UNITED STATES PATENT AND TRADEMARK OFFICE

| APPLICATION NO. | FILING DATE | FIRST NAMED INVENTOR | ATTORNEY DOCKET NO. | CONFIRMATION NO. |
|-----------------|-------------|----------------------|---------------------|------------------|
| 10/754,394 | 01/09/2004 | Michael Frank Walsh | WMFR-P01-001 | 9186 |

Office Action Summary

FIG.1.

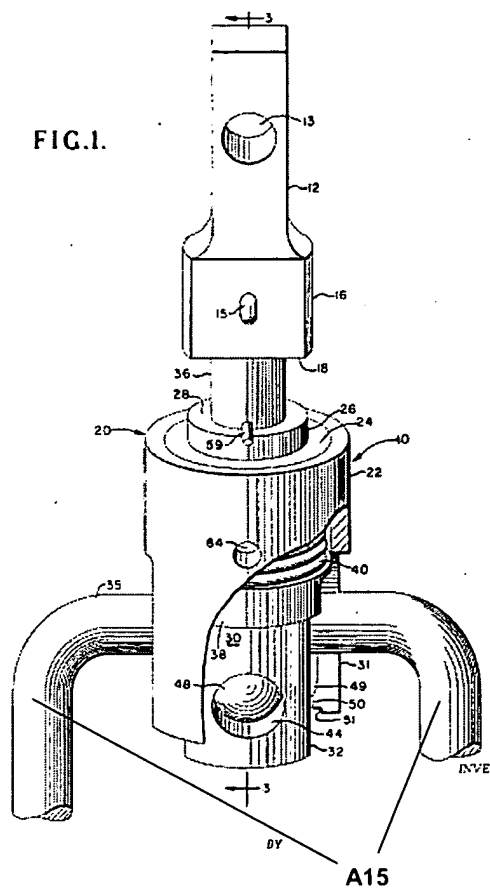
Regarding claim 1, Cannon, Jr., discloses, in Figures 1 and 3, a low-force release mechanism comprising a main structure **20**, a trap **32**, an internal spring activation element **38,40,36**, at least one trigger **59**, and attachments **A15**. A load force **A10** is distributed away from the trigger **59**. An internal release activation element **36** comprises the release pin **36** and one or more ball bearings **46,48** or slugs interacts with an internal geometry **44** of the trap **32**. The internal spring activation element **38,40,36** comprises an internal spring pin **38**, an internal spring **40**, and a release pin **36**. However, Cannon, Jr. fails to disclose a container attached to the main structure **20** and the trap **32**. Eakin teaches, in Fig. 1, a low-force release mechanism a container attached to a main structure **20** and a trap **32** to be released from being carried.

Regarding claim 9, Cannon, Jr. discloses, in Figures 1 and 3, a low force release mechanism comprising a main structure **20**, a trap **32**, and internal spring activation element **38,40,36**, at least one trigger **59**, and attachments **A15**. The internal spring activation element **38,40,36** comprises an internal spring pin **38**, and internal spring **40**, and a release pin **36**. A load force **A10** is distributed away from the trigger **59**. The internal release activation element **36** comprises the release pin **36** and ball bearings **46,48** or slugs interacts with an internal geometry **44** of the trap **32**. However, However, Cannon, Jr. fails to disclose a container attached to the main structure **20** and the trap **32**; and a string attached to the trigger **59**.

Regarding claim 10, the load force **A10** is distributed to the main structure **20** and to the trap **32**.
